## **El Paso County Park Advisory Board**

## **Agenda Item Summary Form**

**Agenda Item Title:** Springs at Waterview Preliminary Plan and Final Plat

Agenda Date: December 13, 2017

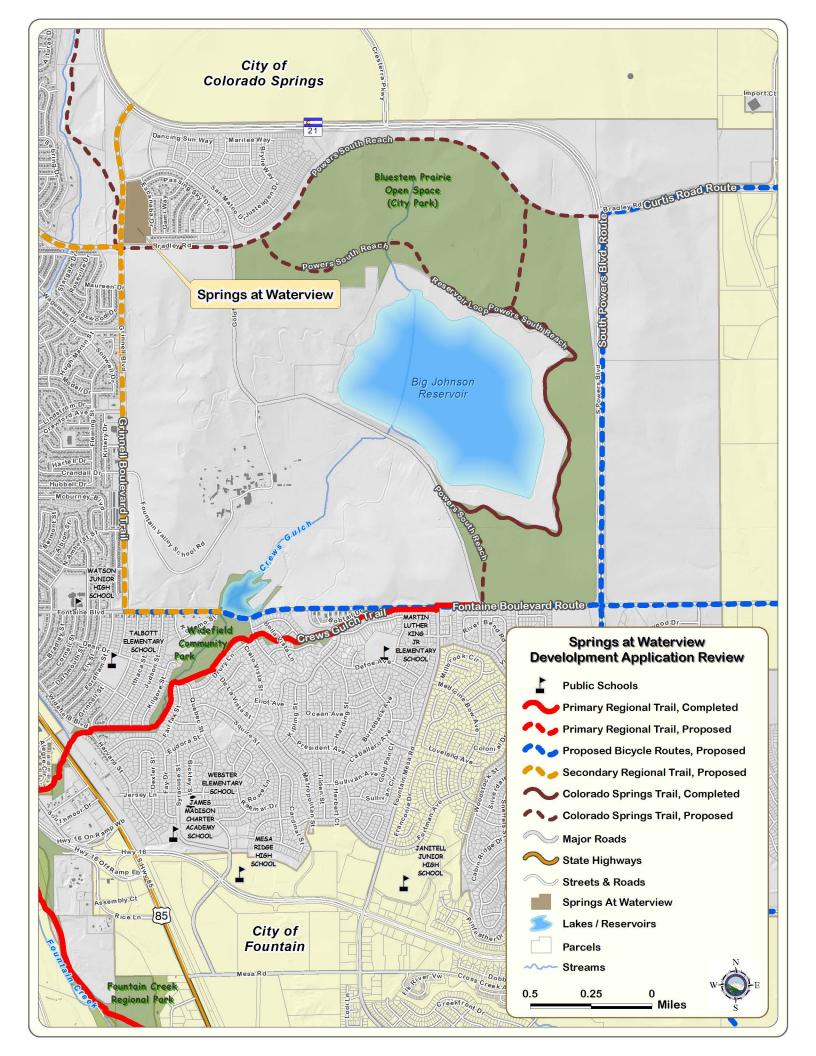
The current Preliminary Plan and Final Plat applications do not show the trail easement on the west side of Grinnell Boulevard north of Bradley Road, nor is there mention of the trail easement in the Preliminary Plan or Final Plat general notes or letters of intent. As such, El Paso County Parks recommends that Springs at Waterview Preliminary Plan and Final Plat (1) designate and provide to El Paso County a 25-foot trail easement along the west side of Grinnell Boulevard, north of Bradley Road to Powers Boulevard, that allows for public access, as well as construction and maintenance by El Paso County of the Grinnell Boulevard Secondary Regional Trail, (2) show the easement on the Preliminary Plan and Final Plat, and dedicate the aforementioned easement to El Paso County prior to the recording of the Final Plat, (3) and pay fees in lieu of land dedication for regional and urban park purposes at time of the recording of the Final Plat.

Recommend to the Planning Commission and the Board of County Commissioners that the approval of Springs at Waterview Preliminary Plan includes the following conditions: (1) designate and provide to El Paso County a 25-foot trail easement along the west side of Grinnell Boulevard, north of Bradley Road to Powers Boulevard, that allows for public access, as well as construction and maintenance by El Paso County of the Grinnell Boulevard Secondary Regional Trail, (2) fees in lieu of land dedication for regional park purposes in the amount of \$31,339 and urban park fees in the amount of \$19,789 will be required at time of the recording of the Final Plat.

Recommend to the Planning Commission and the Board of County Commissioners that the approval of Springs at Waterview Final Plat includes the following conditions: (1) show on the Final Plat and dedicate to El Paso County a 25-foot trail easement along the west side of Grinnell Boulevard, north of Bradley Road to Powers Boulevard, that allows for public access, as well as construction and maintenance by El Paso County of the Grinnell Boulevard Secondary Regional Trail, (2) require fees in lieu of land dedication for regional park purposes in the amount of \$31,339 and urban park fees in the amount of \$19,789.
